Subject: COWL GRILLE POOR APPEARANCE	Bulletin No: 09-002/16
	Last Issued: 01/06/2016

2016 CX-3 vehicles with VINs lower than JM1 DK ***** 120952 (produced before November 18, 2015)

OK	Poor Appearance

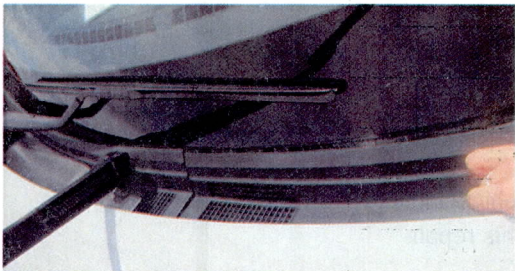
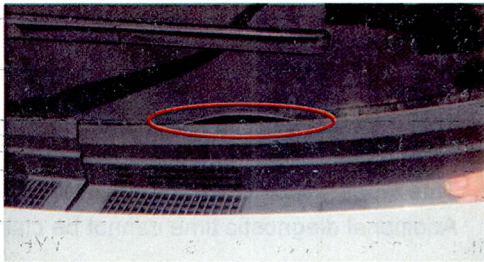
1. The bottom of the window shield is visible when the cowl grille is pushed.

1. Verify customer concern.
2. Replace both side cowl grilles. Refer to MS3 online or Workshop Manual (section 09-16 COWL GRILLE REMOVAL/INSTALLATION).
3. Verify repair.

OK	Poor Appearance

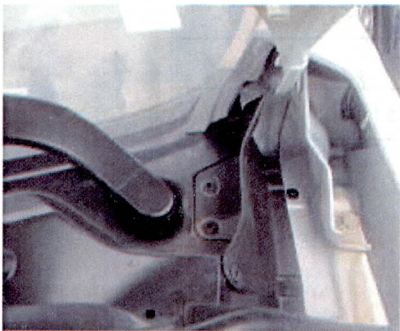
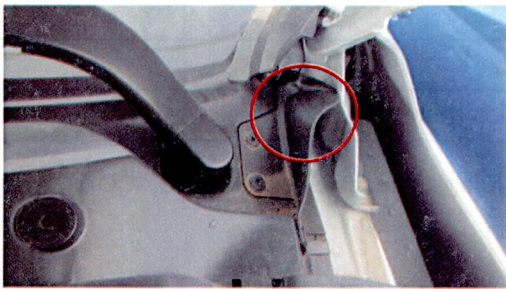
2. The side cover of the cowl grille is deformed.
